ADDENDUM NUMBER 3

JOB #01613.00

Sanitary Sewer for Northwest High School

NORTHWEST HIGH SCHOOL

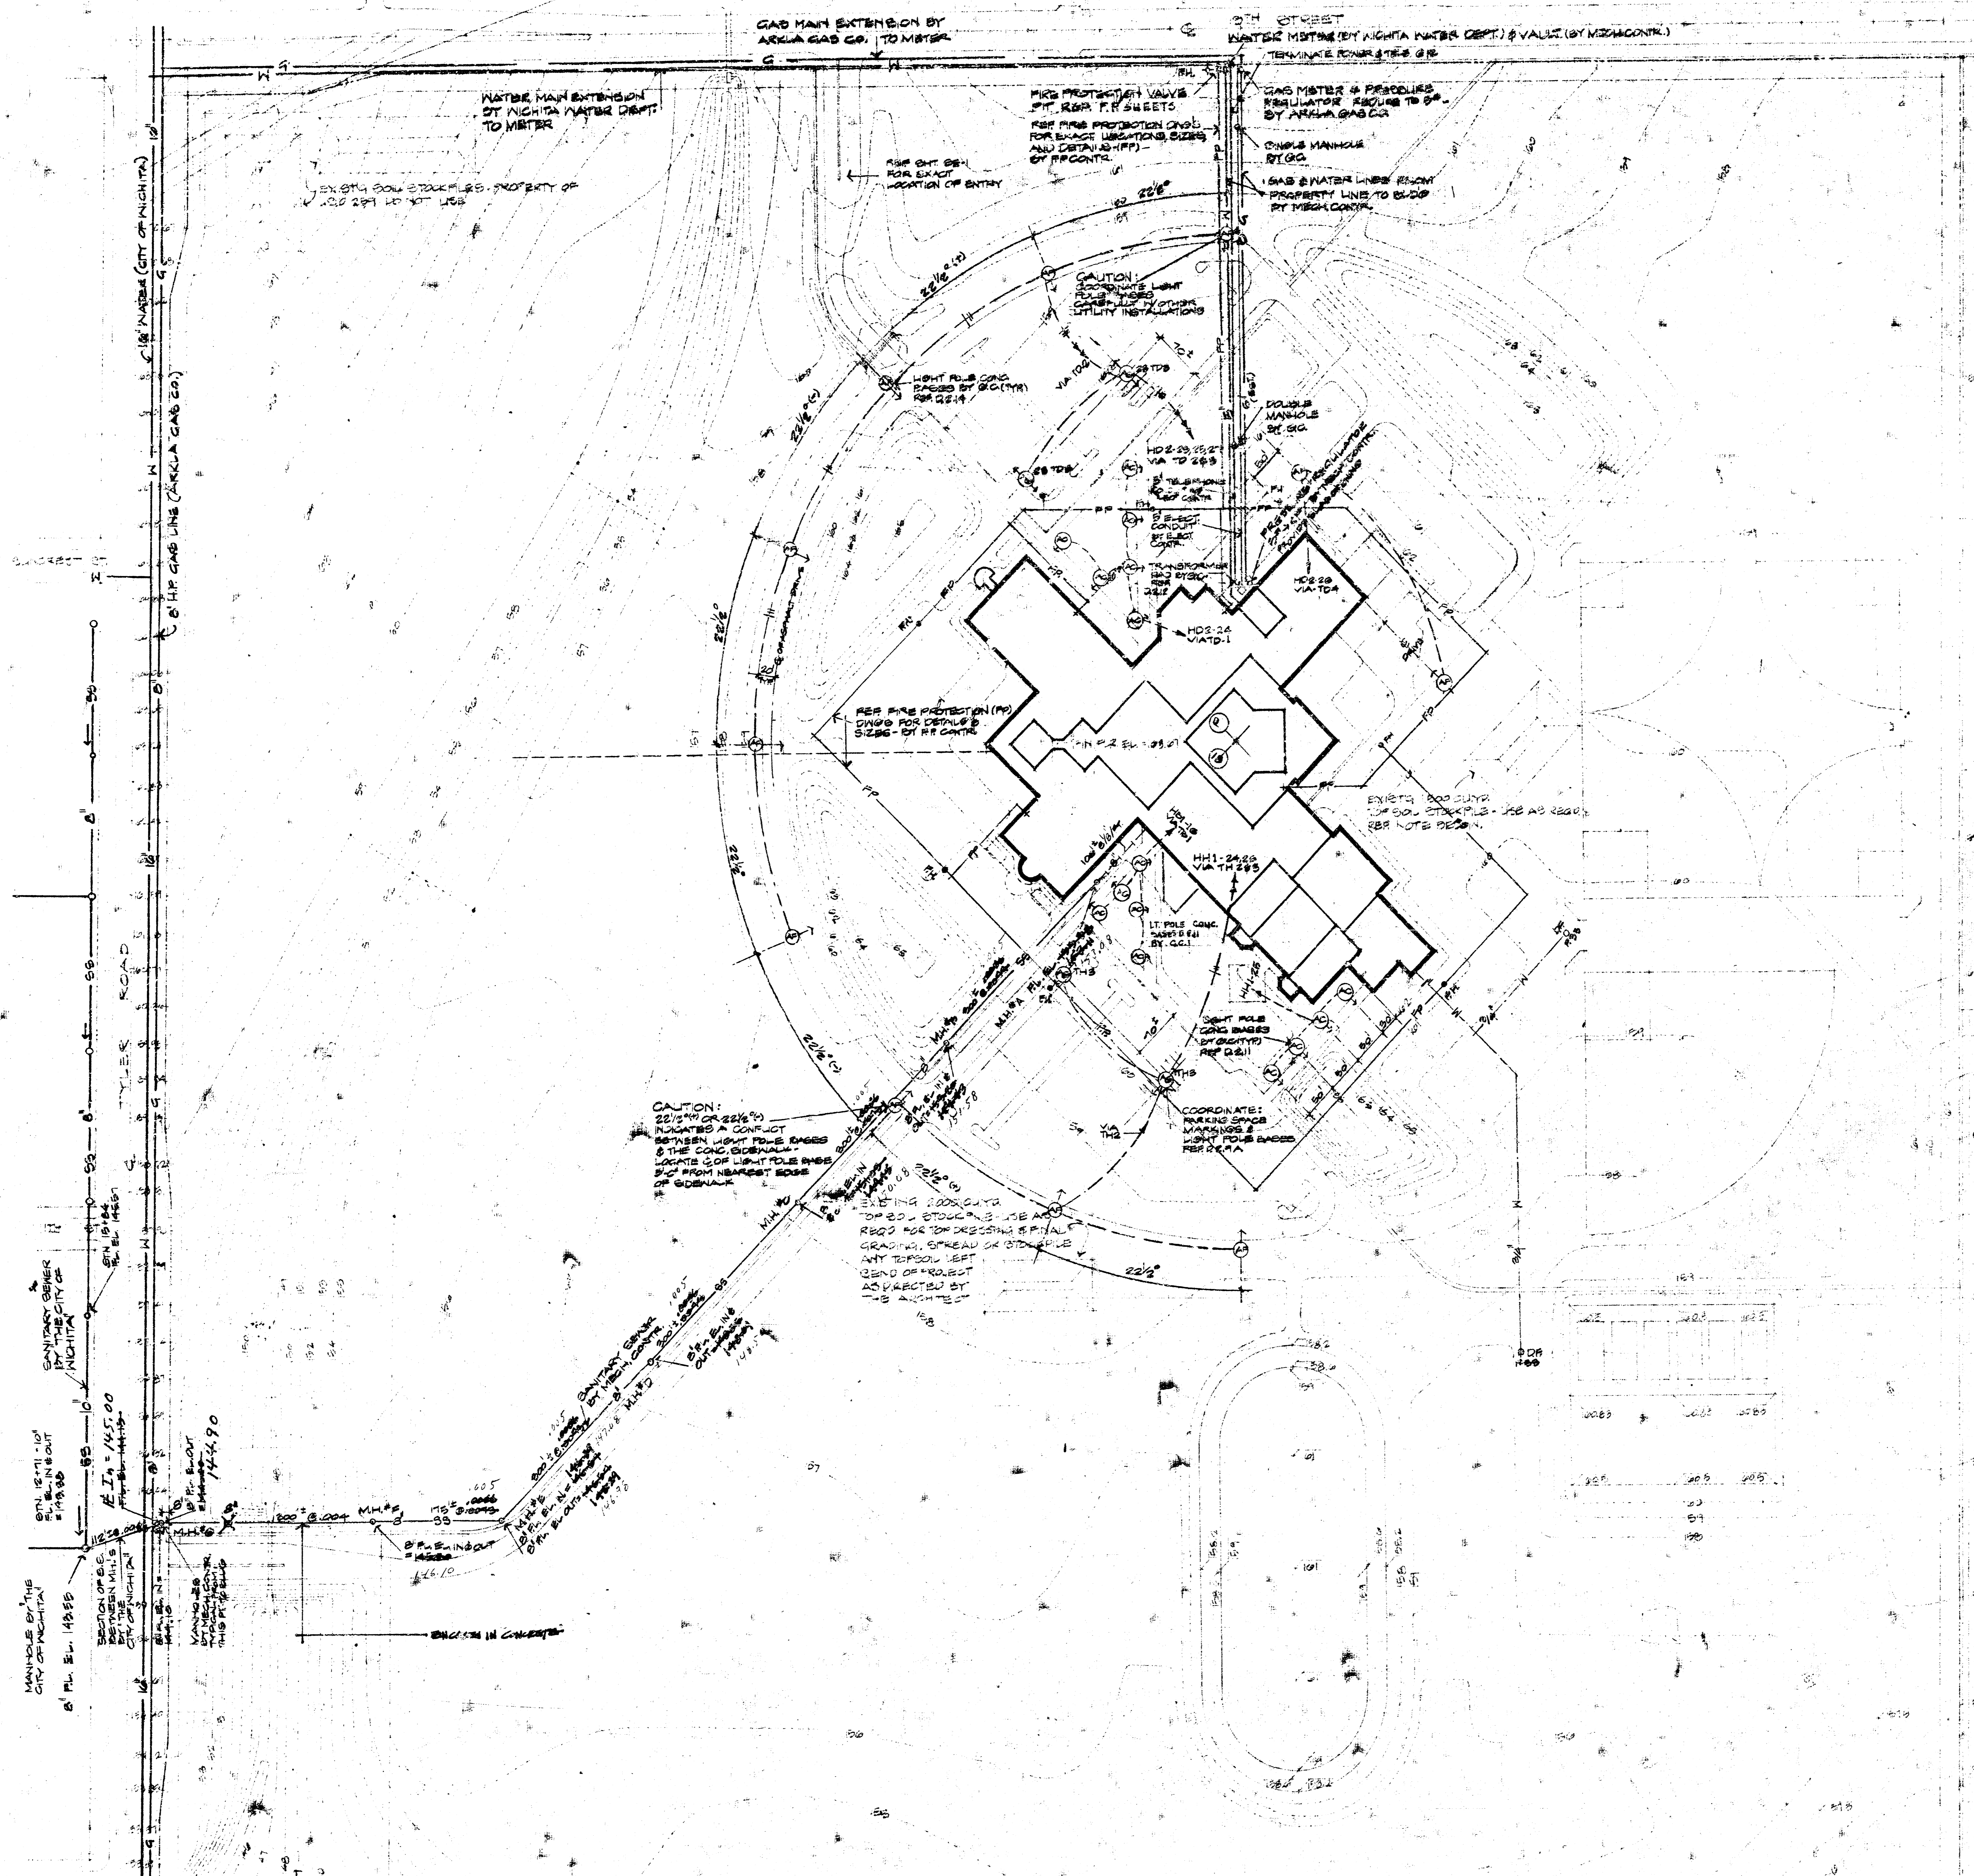
ITEM #3-M37:  
DRAWING SHEET SE-3 - REVIS. ALL REFERENCES TO ENGINEERED SANITARY SEWER SLOPE OF .0073 TO READ .0056.

ITEM #3-M38:  
DRAWING SHEET SE-3 - REVISE CERTAIN ENGINEERED SANITARY SEWER FLOW LINE DESIGNATIONS AS HEREIN INDICATED:  
MANHOLE #A FLOW LINE ELEVATION IN AND OUT = 153.11  
MANHOLE #B FLOW LINE ELEVATION IN AND OUT = 151.43  
MANHOLE #C FLOW LINE ELEVATION IN AND OUT = 149.75  
MANHOLE #D FLOW LINE ELEVATION IN AND OUT = 148.07  
MANHOLE #E FLOW LINE ELEVATION IN = 146.39  
MANHOLE #E FLOW LINE ELEVATION OUT = 146.29

ITEM #3-M39:  
DRAWING SHEET SE-3 - DELETE FLOW LINE ELEVATION REFERENCE AT MANHOLE #G READING; "F.L. EL. 144.15".

DRAWING SHEET SE-3 - RE: APPROXIMATELY 30' FT. OF ENGINEERED SANITARY SEWER PIPING BETWEEN MANHOLES NO. 'F' AND 'G':  
A) DELETE SIZE DESIGNATION OF 10" AND INSERT 8"  
B) THIS SECTION OF PIPING SHALL BE ENCASED IN CONCRETE; CONCRETE SHALL EXTEND A MINIMUM OF 6" BEYOND PIPE IN ALL DIRECTIONS.
